Agenda Item 3
710 Green Briar Lane
Revisions to Previously Approved Plans

Consideration of a request for revisions to previously approved plans for a new residence on a vacant lot.

The property owner now wishes to proceed with development of the property, with a modified plan. The owner submitted modified plans for permit and after review, staff determined that the changes made were significant enough to require further Board review. The reason for the modified plan based on information from the petitioner, is to reduce the amount of second floor living space and by doing so, reduce the cost of construction. The project is now moving forward, with a new architect and civil engineer. The architect who originally designed the house is no longer involved with the project. The request now before the Board seeks approval of changes including changes to the footprint of the residence, the overall massing and roof forms.

Review of Proposed Changes and Comparison to the Previously Approved Plan

PREVIOUSLY APPROVED SITE PLAN

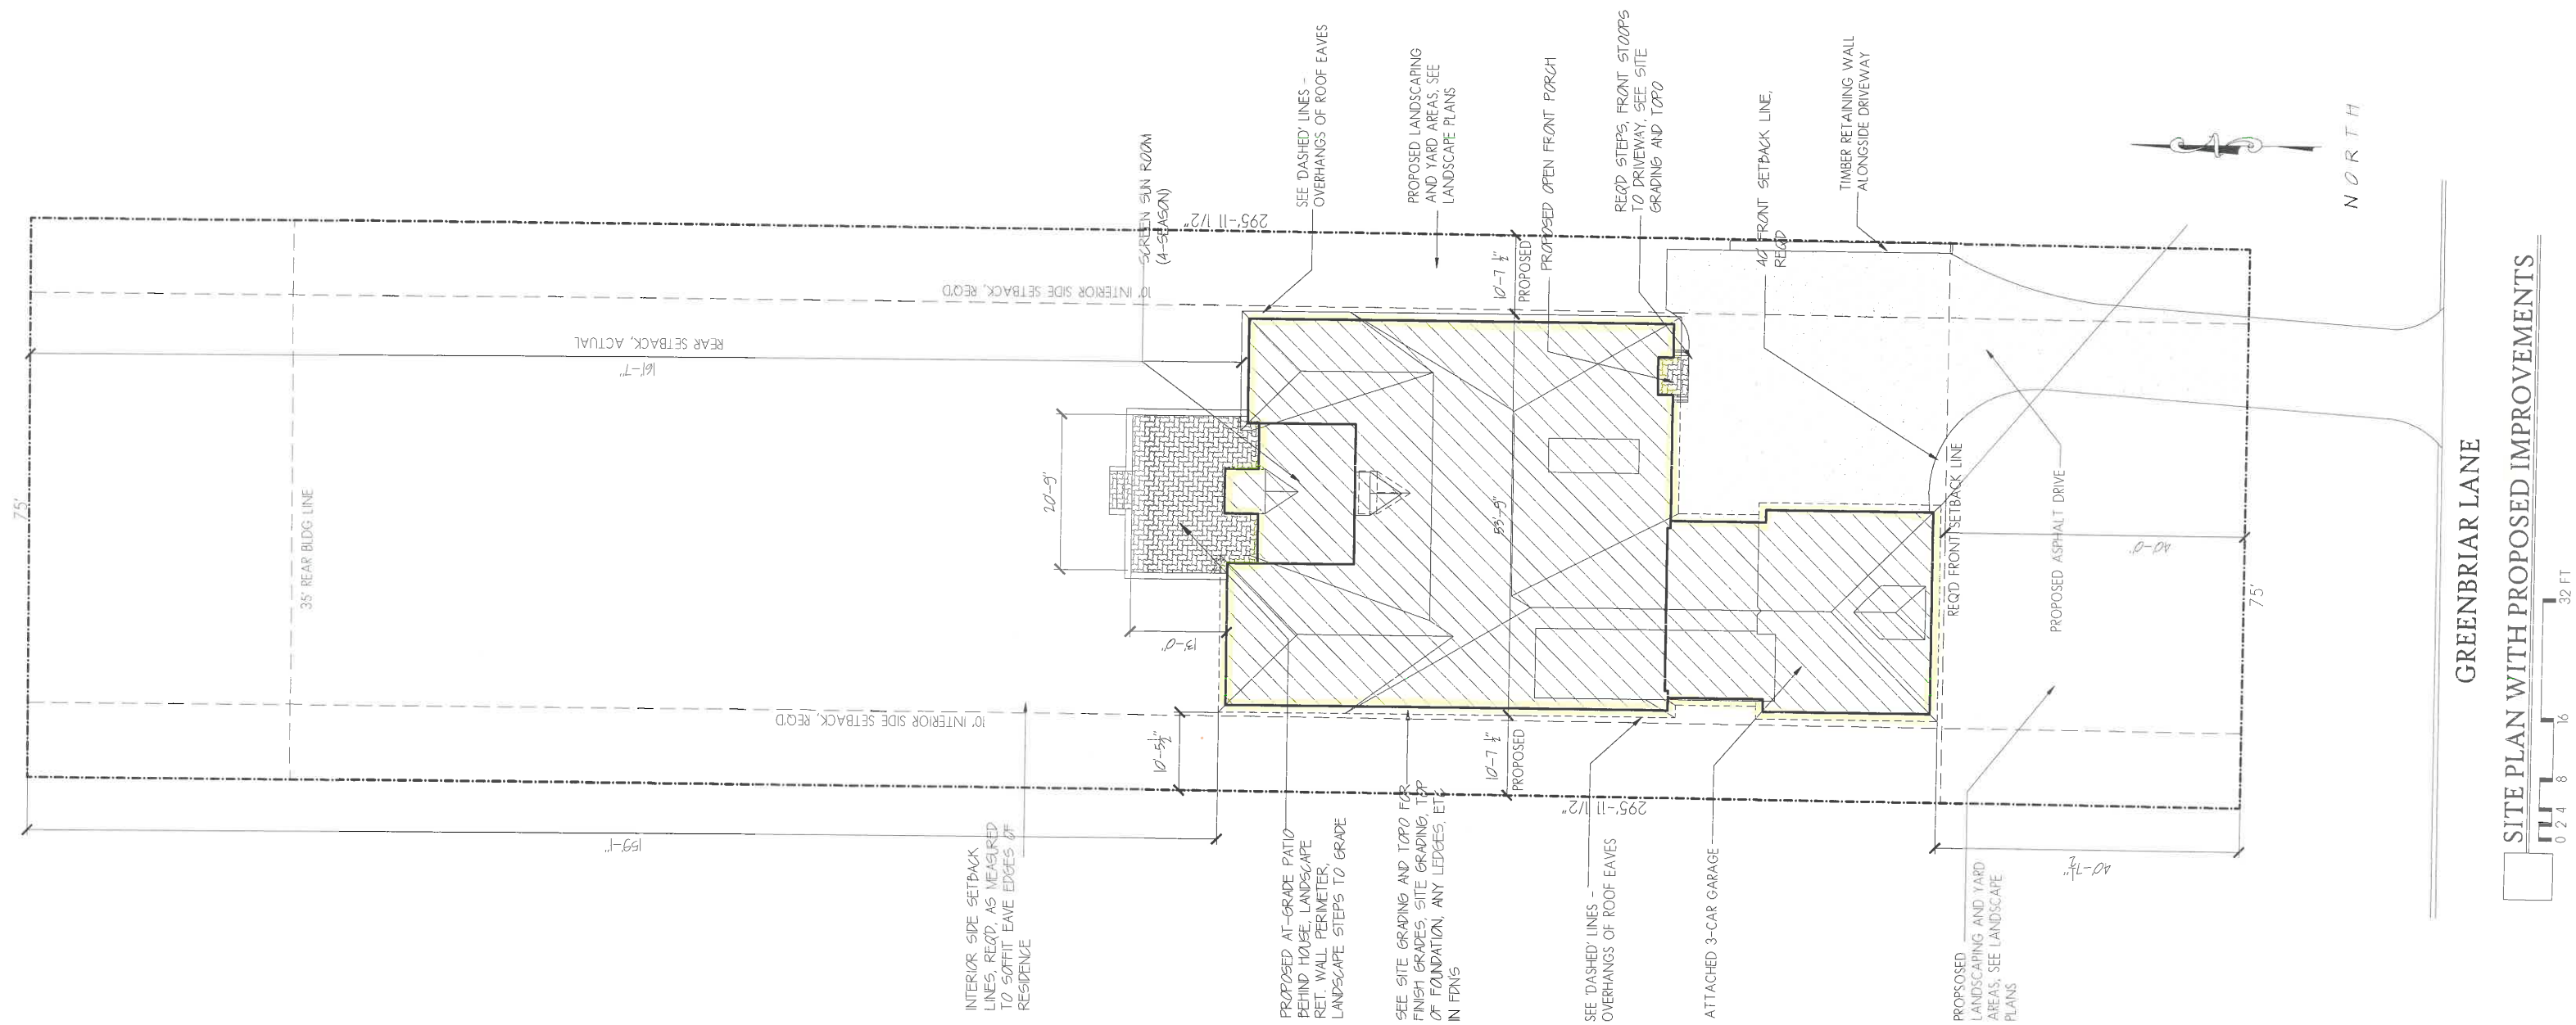
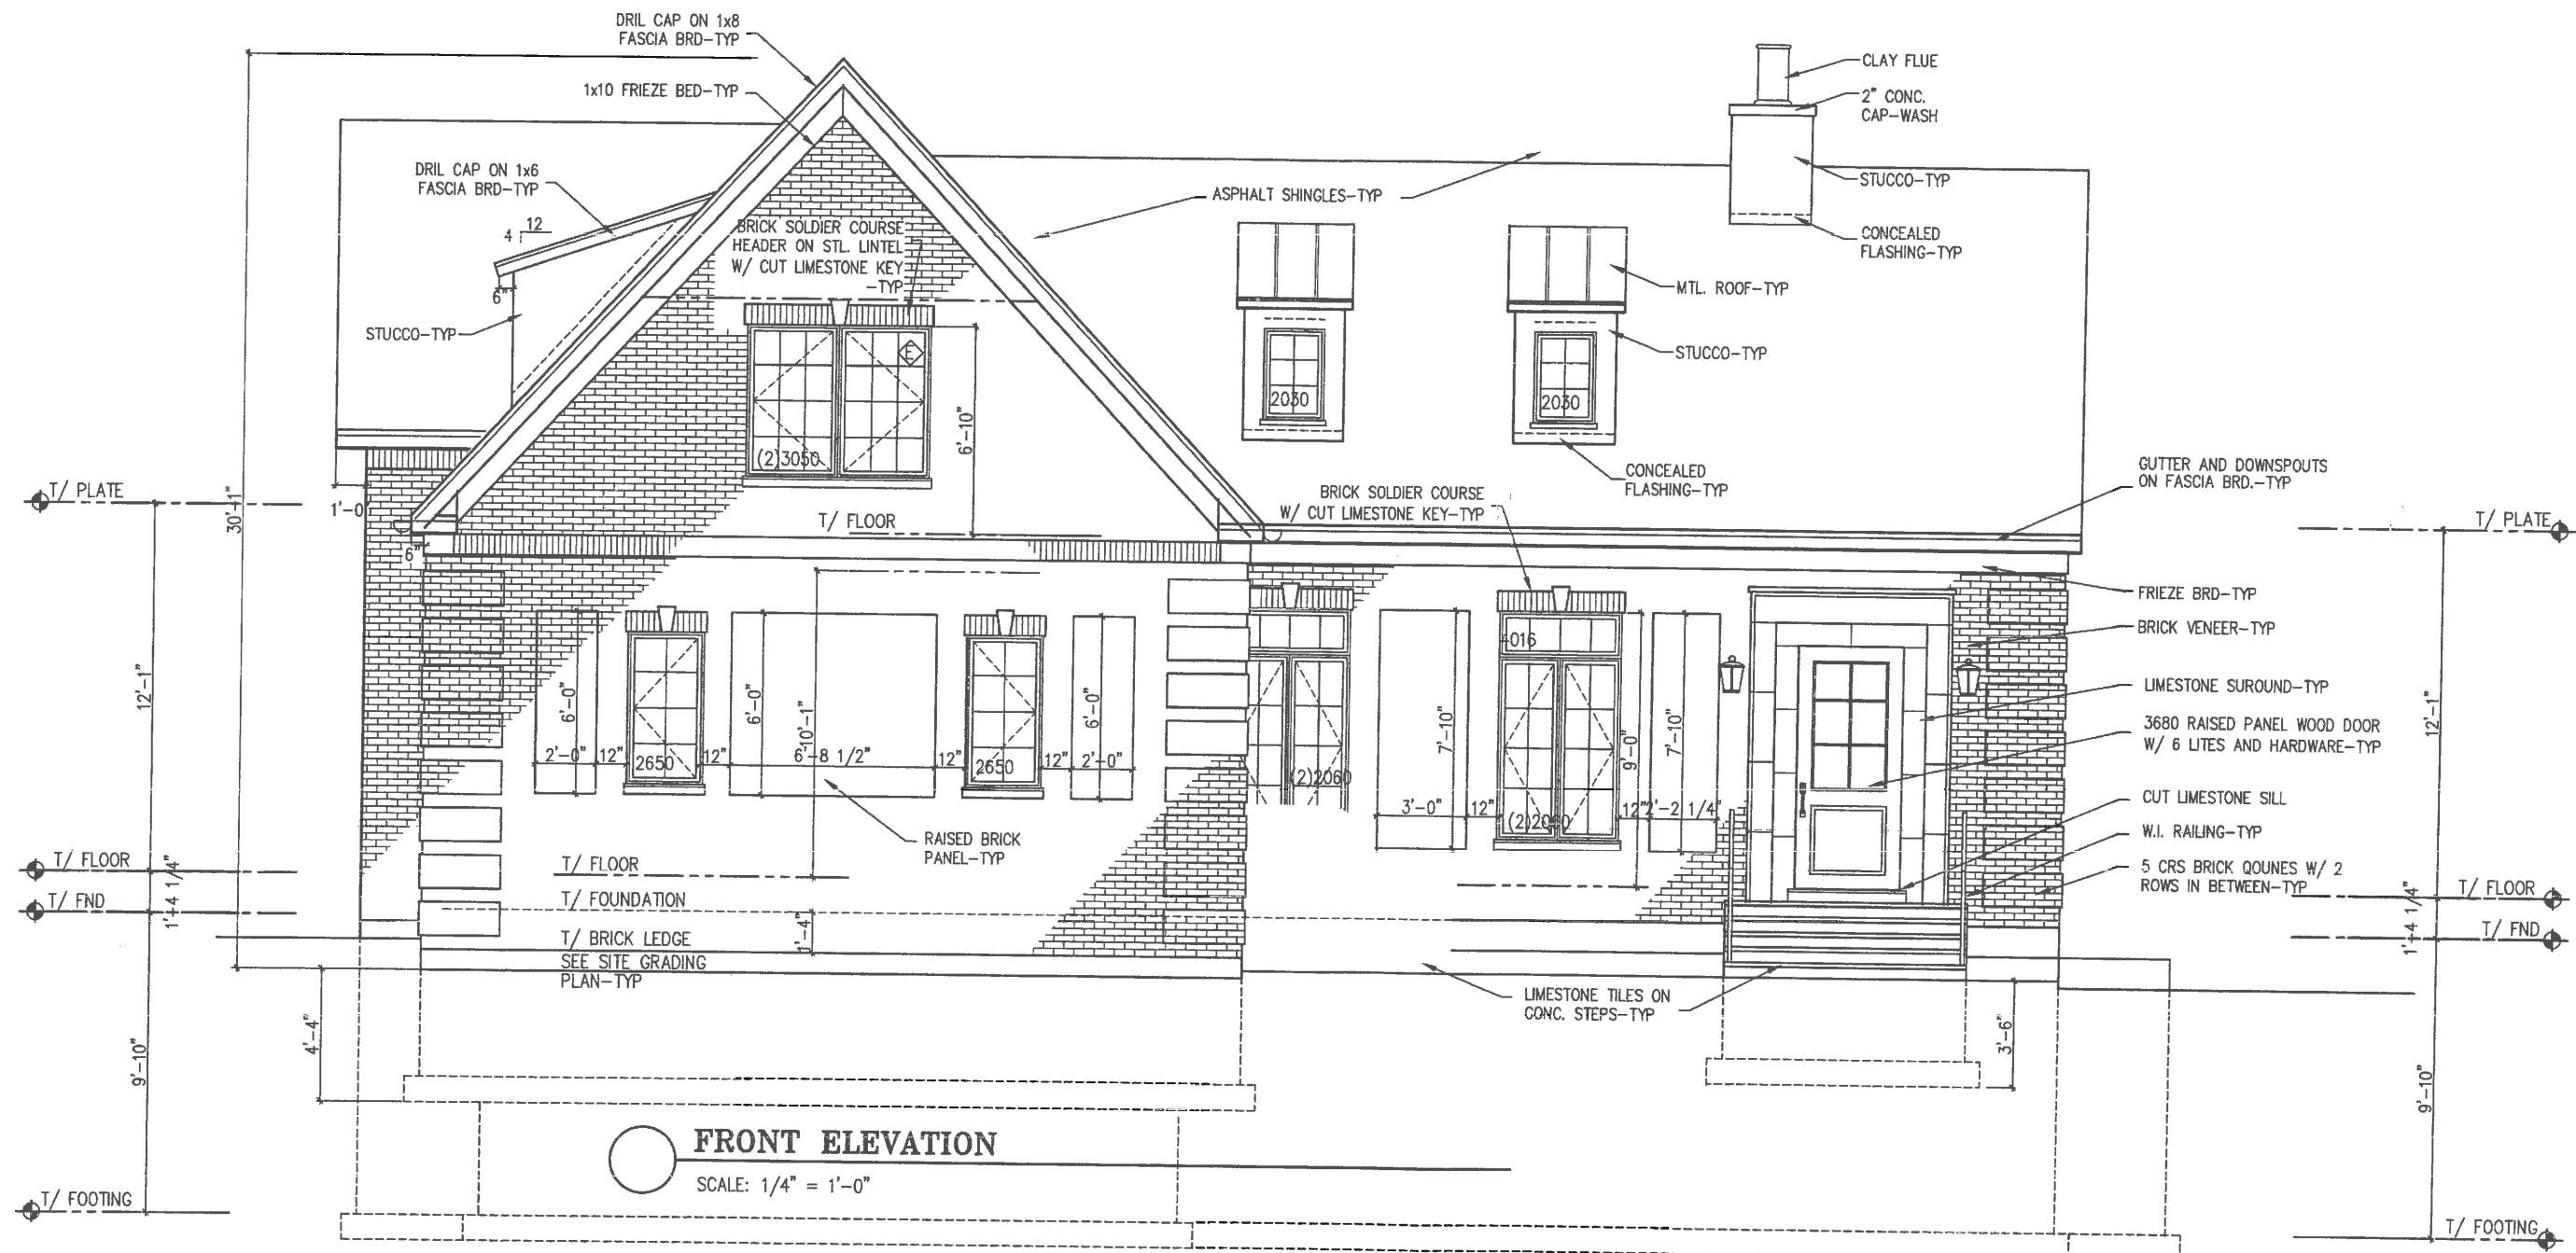
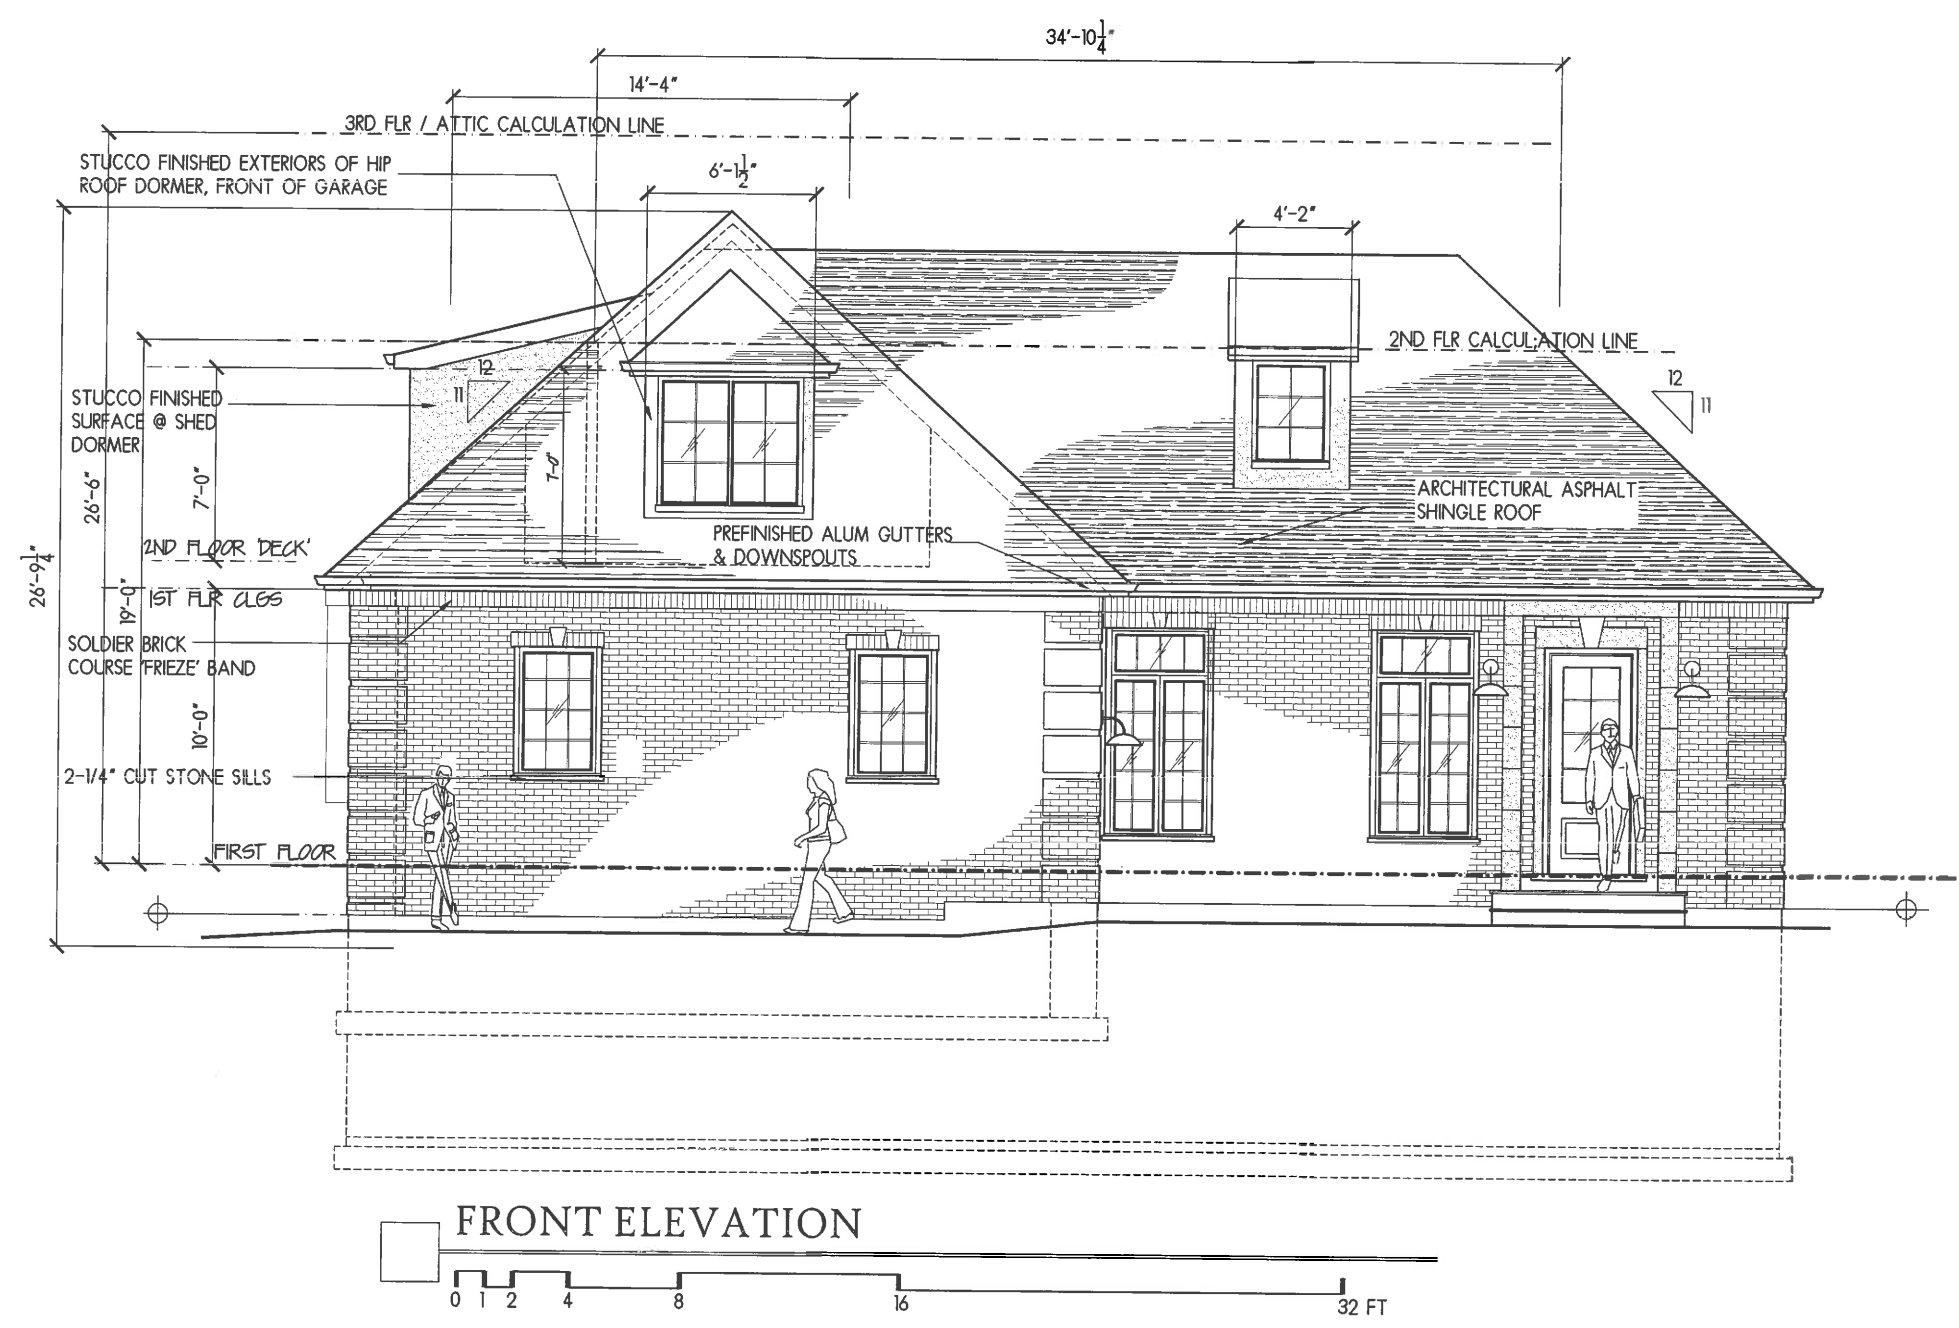
This standard is met. The plans as now proposed reflects a more compact building footprint. The garage element at the front of the house is shortened in the revised plan, the mudroom between the garage and house was removed. The location of the garage mass is consistent with the previously approved plans with the south wall of the garage. The main mass of the house is shifted approximately 16 feet closer to the front of the property. The driveway configuration is slightly different as reflected on the plans included in the Board's packet. The location of the curb cut remains the same as previously approved.

As noted in the previous discussions about this property, the City Engineer is well aware of some unique drainage issues in the area. A drainage easement will be required at the rear of the property to allow stormwater to continue to move through the property toward the Lake. Discussions about drainage with the neighbor to the east have occurred in the past, staff will share the updated drainage and grading plans with the neighbor and will be available to meet on site if desired.
